**COMMENTS OF THE COUNCIL OF INDUSTRIAL BOILER OWNERS
on
EPA Proposed Rule**

*National Emission Standards for Hazardous Air Pollutants for Major Sources: Industrial,
Commercial, and Institutional Boilers and Process Heaters*

75 Fed. Reg. 32006, EPA-HQ-OAR-2002-0058

August 20, 2010

EPA's “Difference From Zero” Approach

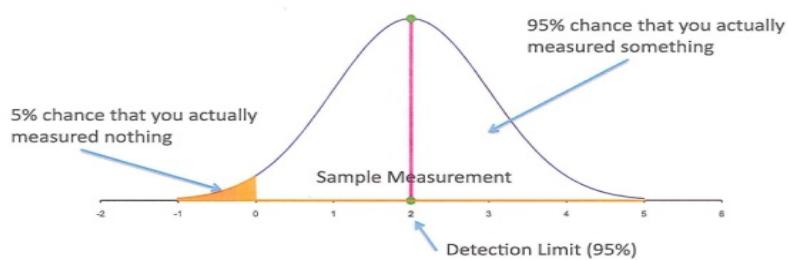
EPA's 'difference from zero' approach to detection limits places the 95% confidence limit of the measurement probability curve at zero. The centerpoint of the curve is the value around which the confidence interval is centered, and thus the putative 'true value' for a statistically significant non-zero measurement, i.e., the detection limit:

“Difference From A Blank” Approach

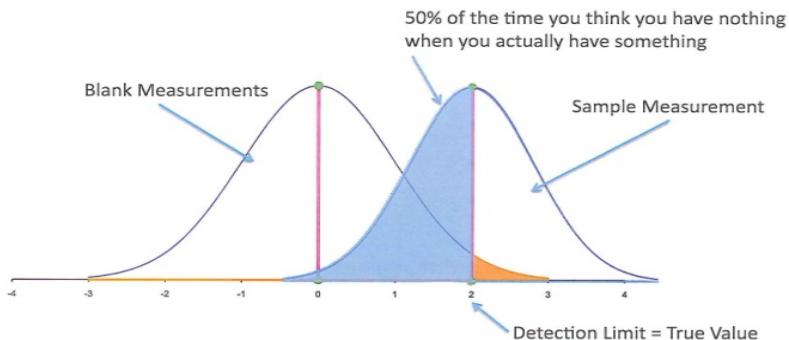
Real world samples exist in matrices which affect the measurement. It is therefore realistic to include a "different from blank" statistic to determine the detection limit. Superimposing the detection limit "statistically greater than zero" curve over a blank "statistically not different from zero" curve gives us this picture:

One Solution

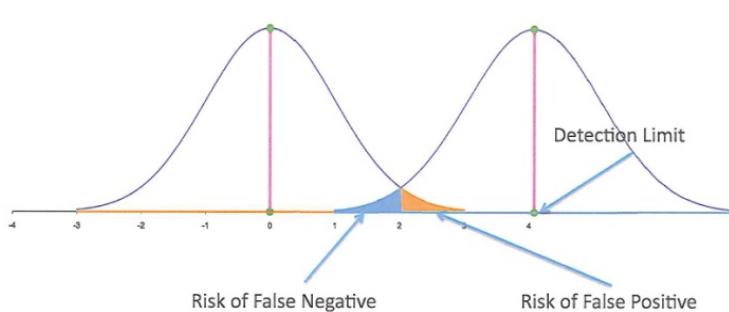
The detection limit is the point where the blank "statistically zero," meets the measurement "statistically not zero." The large (blue) shaded area, below the detection limit, is the zone where there is a better than even chance that one detects nothing when in fact there is something there. The smaller (yellow) shaded area is the 5% probability zone where one concludes the blank is not zero, when it actually is zero. The sum of these two probability zones poses an interesting problem when one measures near the detection limit: more than half the time, one's answer to the question of whether a measure of something different from zero was taken will be wrong. This problem is resolved by setting the detection limit at 4x the standard deviation of replicate blanks, yielding a 95% confidence interval for "difference from a blank," as shown below.⁸ This solution is standard and has been adopted by the International Union of Pure and Applied Chemistry.

Adopted by International Union of Pure and Applied Chemistry (IUPAC)
and most other international organizations

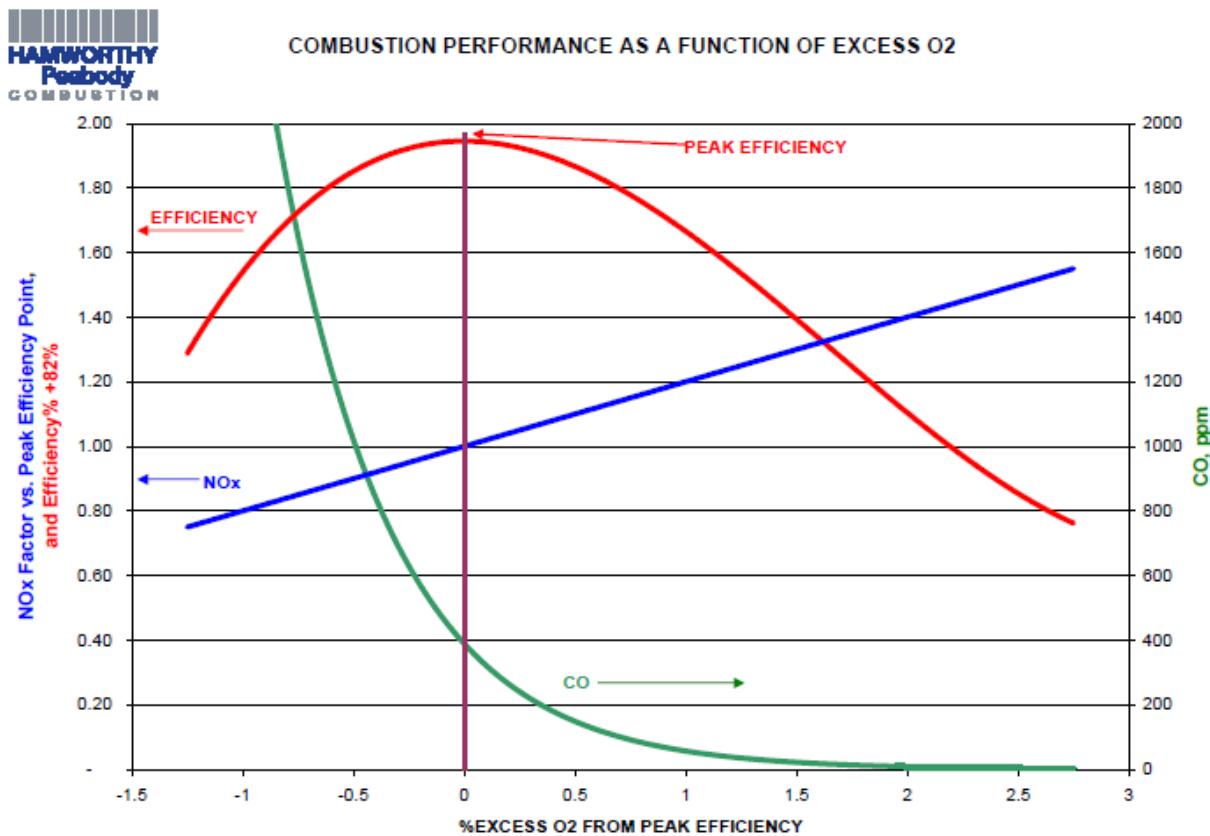
A. Tune-ups are defined to minimize CO, but that will decrease efficiency and will increase overall emissions.

Hamworthy Peabody Combustion (a CIBO member) provided the figure below to indicate the general relationship of (excess O₂ from peak efficiency), CO, NOx, and combustion efficiency for a gas fired burner. This shows relative changes from the peak efficiency point and is generally applicable in form for all fuels. As shown, attempts to focus on reducing CO emissions will lead to increased excess air operation, thereby increasing NOx emissions and decreasing unit efficiency. EPA has failed to recognize this basic reality of burner operation and the negative impact on NOx and energy efficiency, and rather, in their impacts analysis, assumed a 1% improvement in efficiency (75 FR 32037). While there may be units in operation that can improve efficiency, well tuned boilers and process heaters will generally increase NOx emissions and decrease efficiency if the only focus is on reducing CO emissions. In reality, optimum conditions are achieved with CO at some higher level. CIBO recommends that EPA amend the rule so that tune-ups also consider optimizing efficiency, limiting increases of NOx, and ensuring safety, not focusing on minimizing CO. In fact, EPA is correct in its definition of "Tune-up" in that it specifies "to optimize combustion efficiency" (63.7575). In contrast, 63.7540(a)(10)(iv) stipulates "minimize total emissions of CO." The latter needs to be changed to recognize the need for optimization in recognition of all appropriate factors.

30 Day Average Calculation of HCl for a Boiler Equipped with a Spray Dryer Absorber

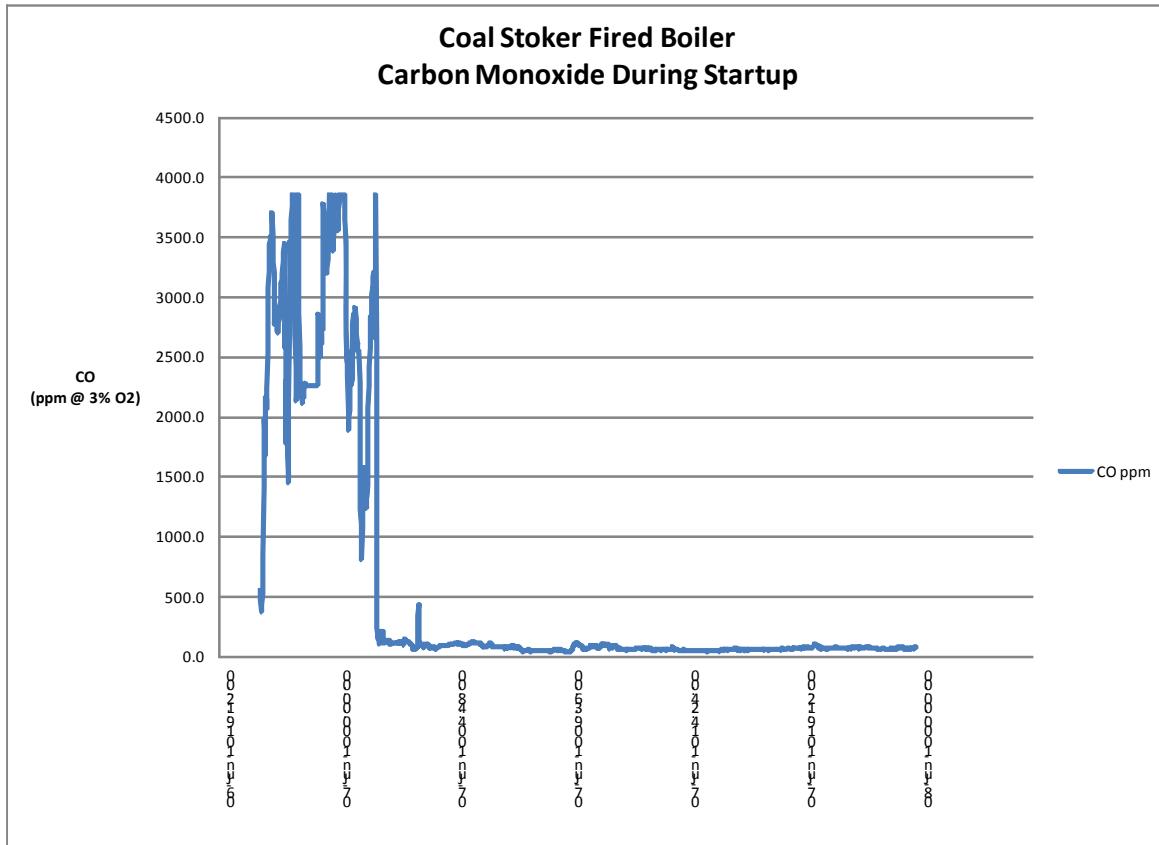
Such a scenario would result in a unit being out of compliance because EPA inappropriately failed to craft a compliance protocol to address the fact that emissions performance during startups and shutdowns is necessarily not equivalent to emissions performance during steady-state operation.
